TYPICAL SECTIONS

ROUNDABOUT & PAVEMENT STRUCTURE

<u>Keaau-Pahoa Road Intersection</u> <u>Improvements at Old Government Road</u> <u>Federal-Aid Project No. HSIP-0130(031)</u>

C.O. ADD. 25

AC Pavement Section Detail

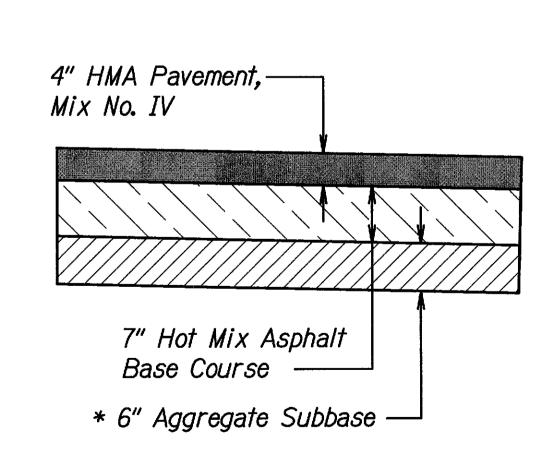
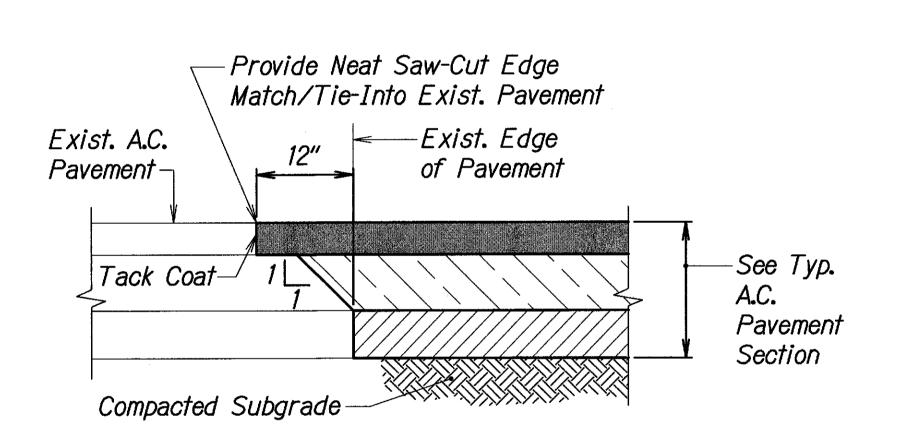
* The 6" Subbase Layer can be Eliminated in Areas where Hard Basalt Rock is Encountered at the depth where the Aggregate Subbase should be placed. However, the Untreated Permeable Base and Asphalt Concrete Base are still required. Refer to Boring Locations and Logs on Sheets B-1 to B-4 for Approximate Locations of Rock.
